PLATE 3 G&D PLAN

CITY OF ALBUQUERQUE
PUBLIC WORKS DEPARTMENT
ENGINEERING GROUP

TRACT 8 AT THE TRAILS UNIT II
GRADING & DRAINAGE PLAN

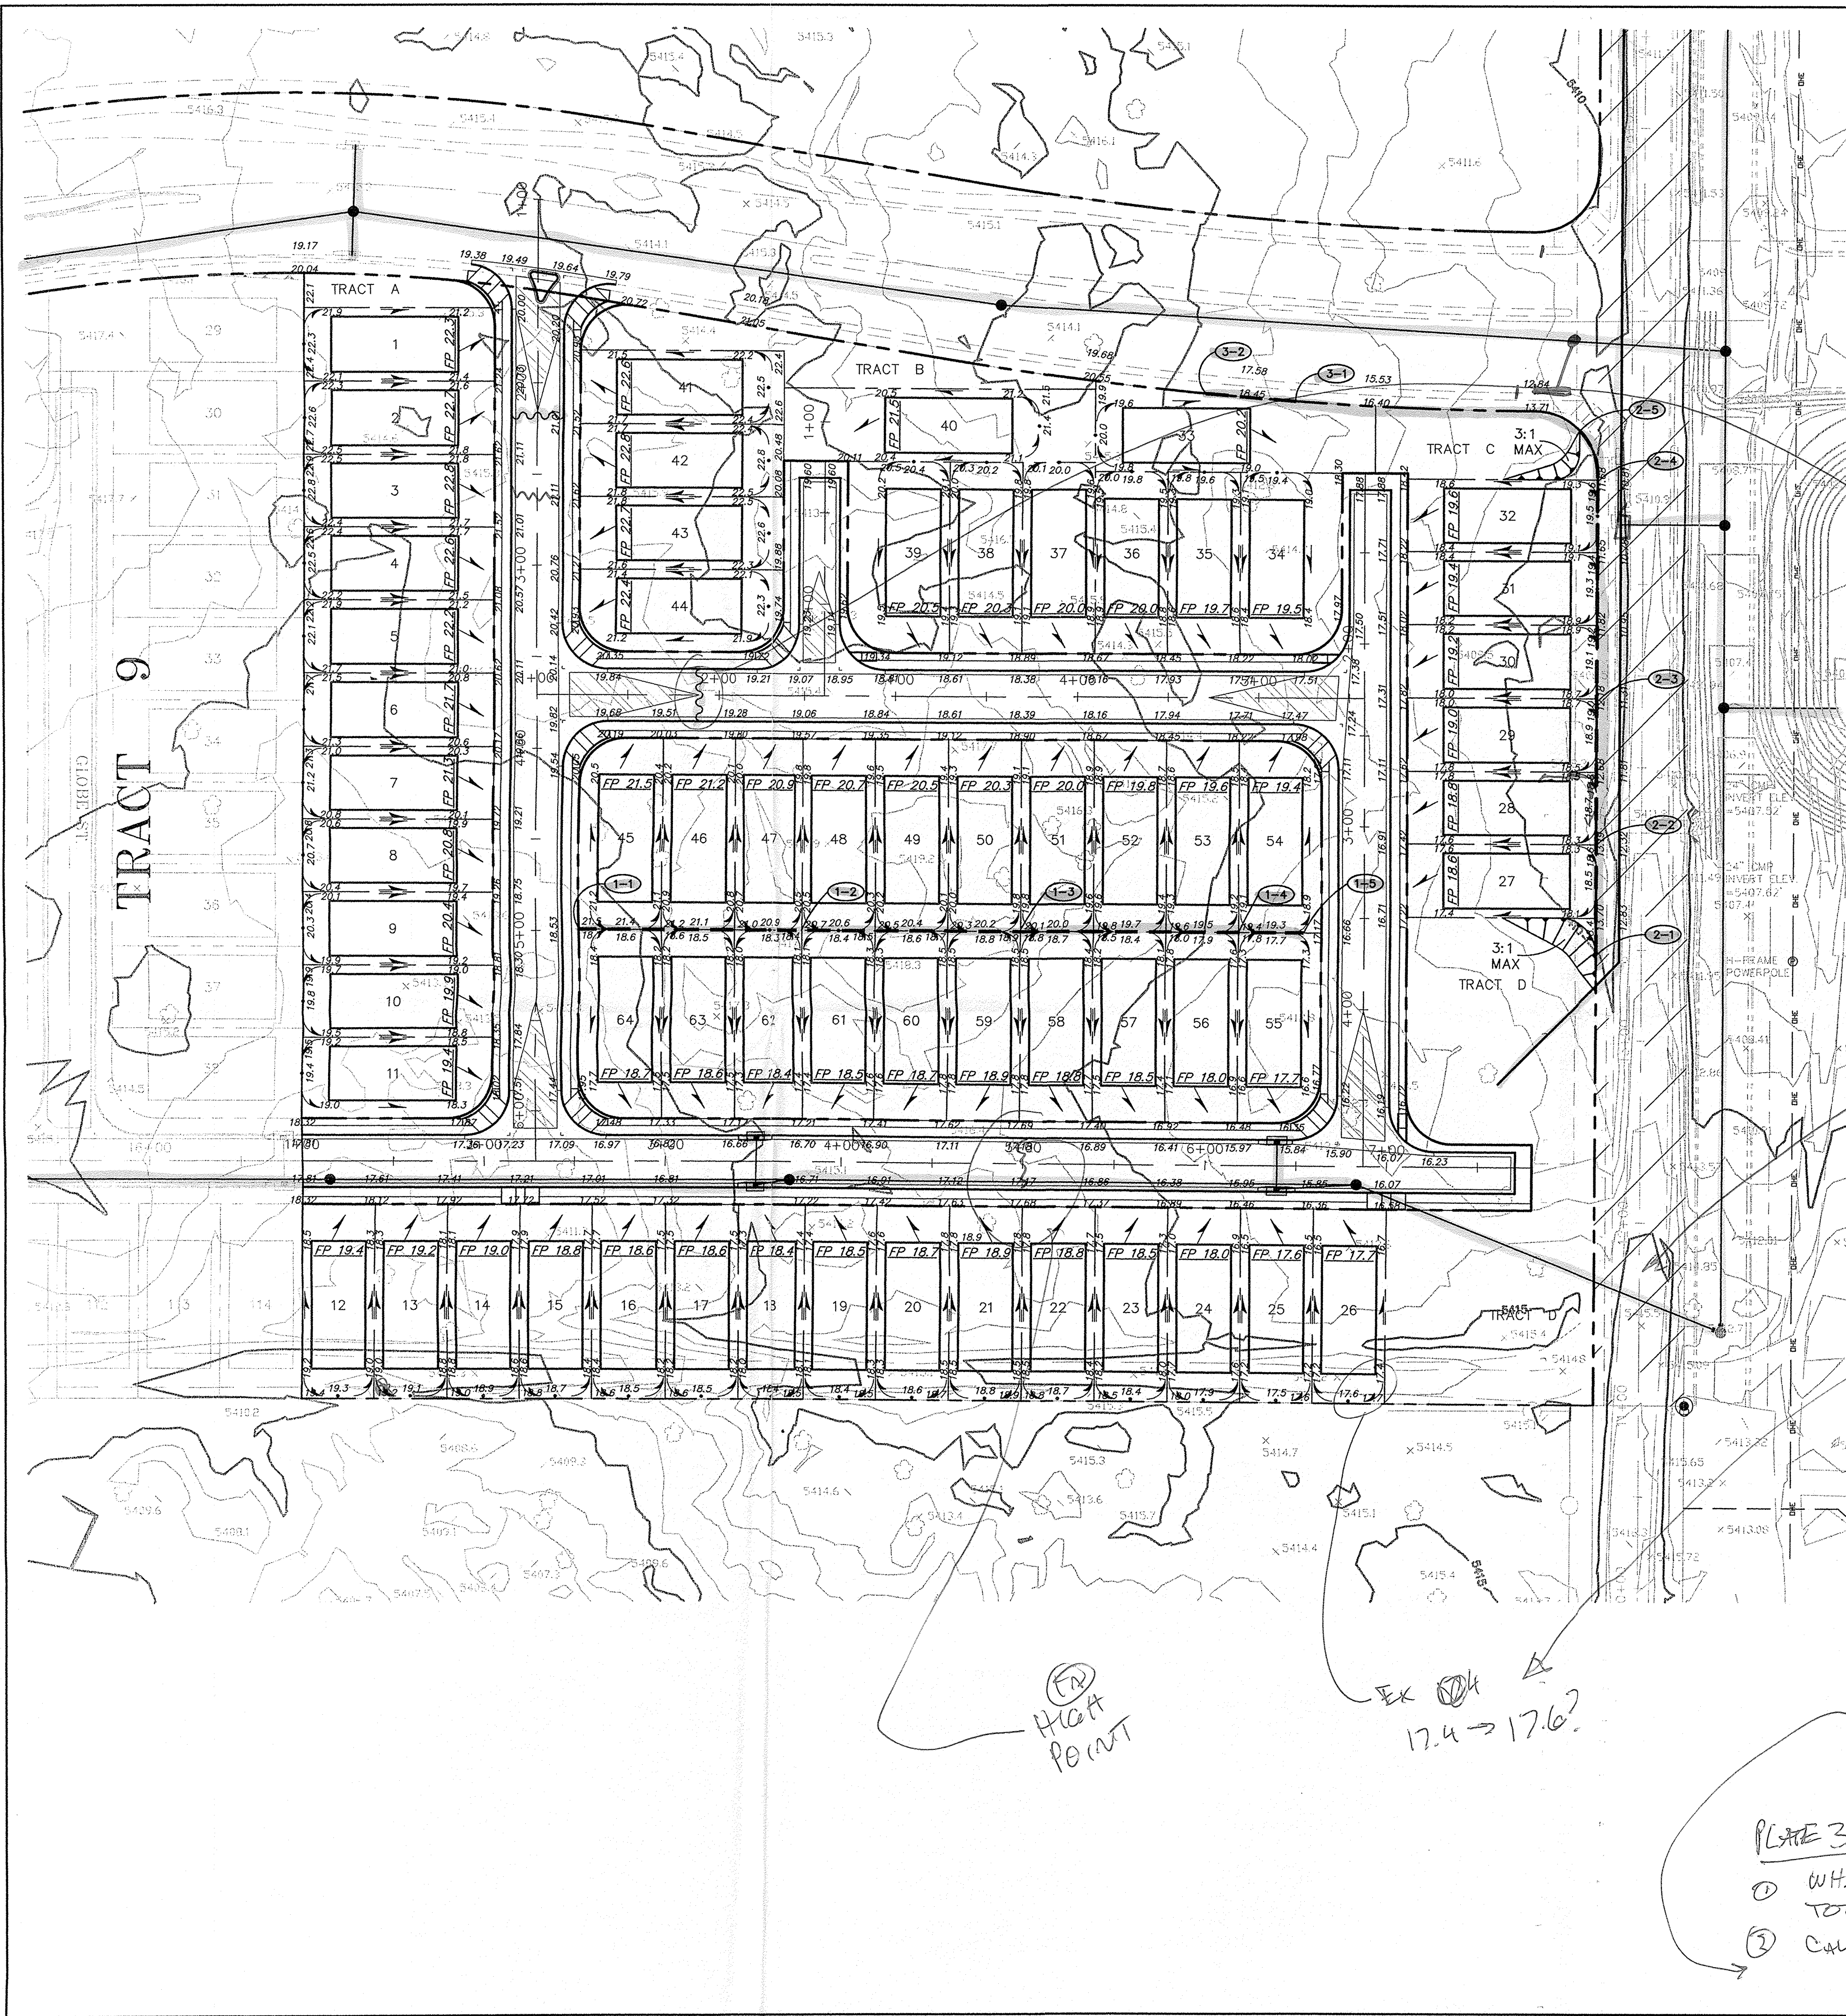
NARRATIVE: NO BREAKDOWN
OF 9.4 AC SITE
w/ 90 TRIMENTS
TO VERIFY 27.31 AC

① NOT @ HIGHPOINT

USE CONSISTENT SYMBOLOLOGY

EASEMENT?

- ① NOT HIGH POINT! MOVE WEST TO INTERSECTION
- ② HIGH POINT NOT CALLED OUT LOT 21/54 INCONSISTENT LINE TYPE
- ③ BACKYARD FLOWS?
- ④ CGG ON LEGEND
- ⑤ FLOW ARROW ON LOT 42 POINTS UPSTREAM
- ⑥ TO HIGH POINT

- ① WHAT DOES "90 DEV (ACRES)" MEAN?
- ② CALCS OFF; SAMEA = 385.12 AC RES - ON HZ" YIELDS 13.06 CFS/AC (NOT!)
- ③ BASIN "DN - E" NOT SHOWN ON P₁ OR P₂ = ONLY EI ON P₁

- ① WHAT HAPPENED TO BASIN 'E' + HZ TOT AREA = 303.15
- ② CALCS OFF, BASIN AREAS ON CALCS

Lot 44/46
